II. Responses to Comments

A. Introduction

C. Comment Letters

Figure 1
VIOLET STREET CREATIVE
OFFICE CAMPUS PROJECT
Sewer Map

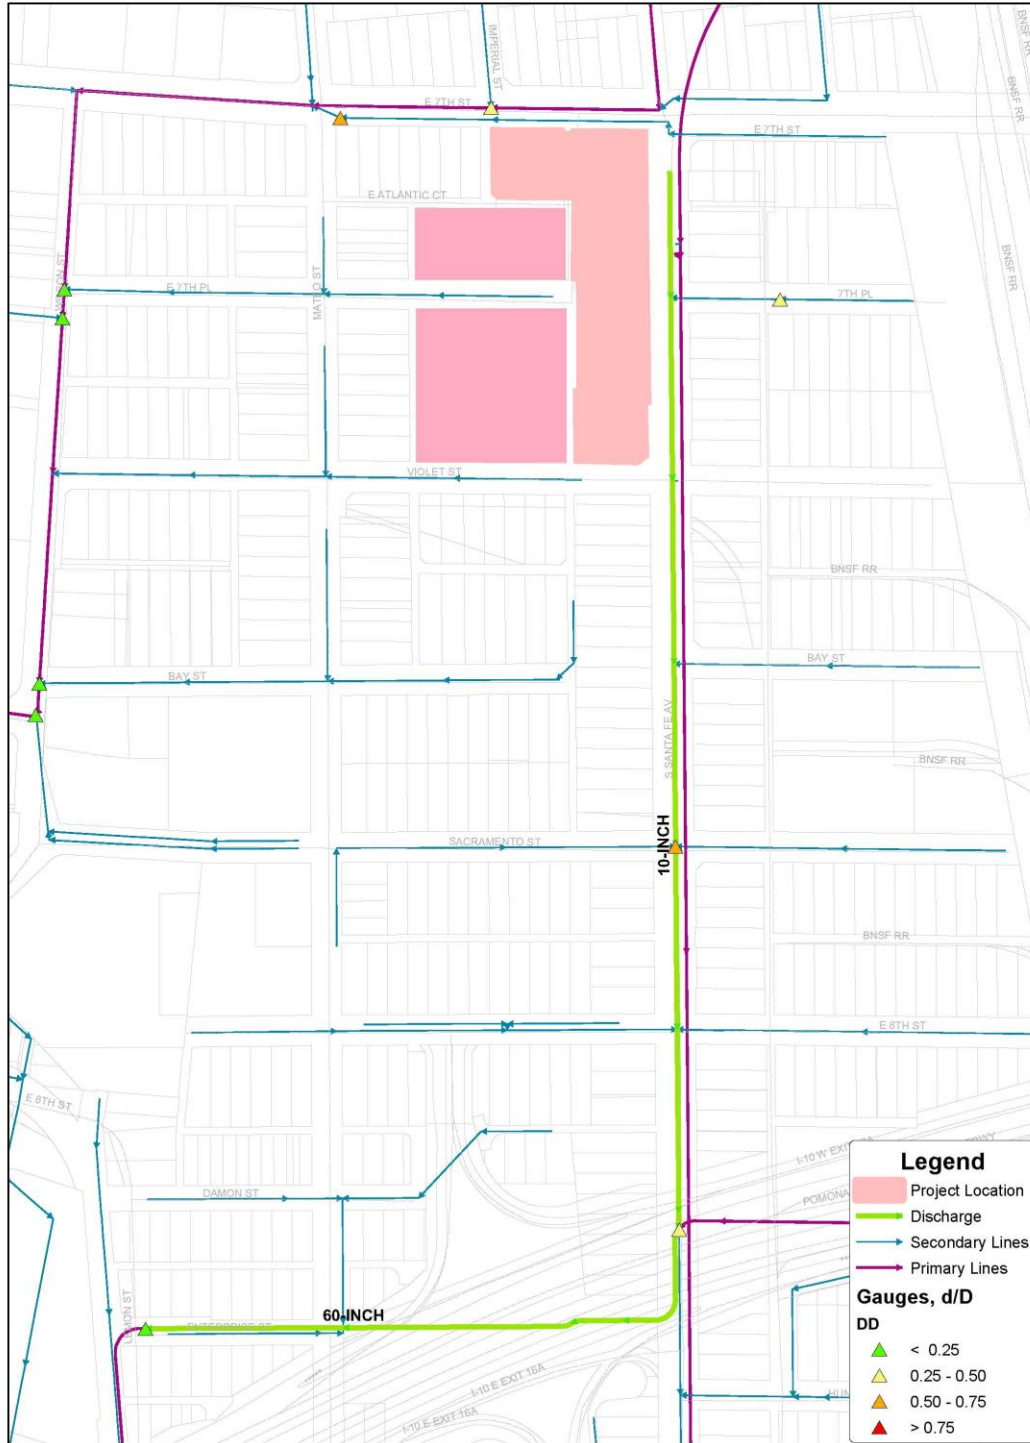
The sewer infrastructure in the vicinity of the proposed project includes an existing 8-inch line on Santa Fe Avenue. The sewage from the existing 8-inch line feeds into a 10-inch line on Santa Fe Avenue before discharging into a 60-inch sewer line on Enterprise Street. Figure 1 shows the details of the sewer system within the vicinity of the project. The current flow level (d/D) in the 8-inch line cannot be determined at this time without additional gauging.
